Reflection Report on Bridge Corrosion

1 Changes in Response to Feedback

Figure 1: UsesHierarchy before

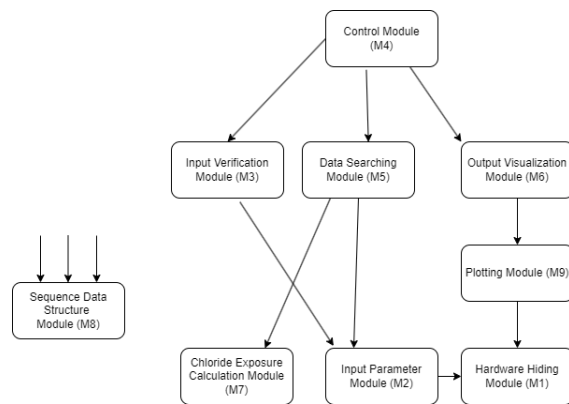
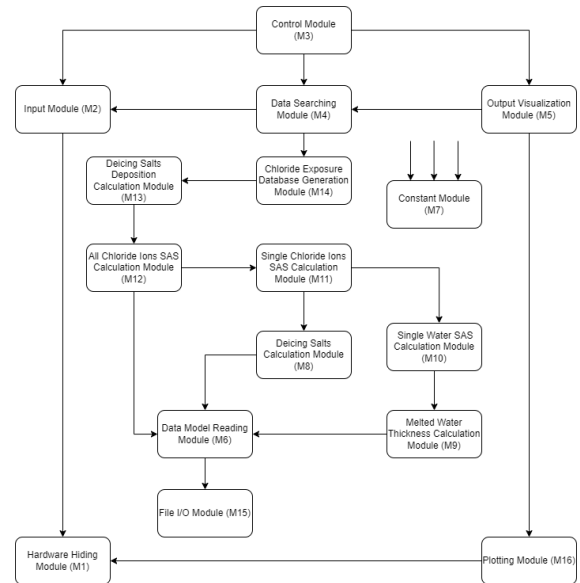
In the first version of my software, I put the calculation process within one module, but then I realize that is not detailed enough and it will be hard for information hiding, as each step of the calculation has its own secret, which is the different formula. So I separate the calculation by steps, with one step aiming to solve a single equation. This is also good for maintainability, if the formula for one step changes, only the corresponding module need to be changed. The Use Hierarchy changes correspondingly as well, the comparsion could be found in Section 4.
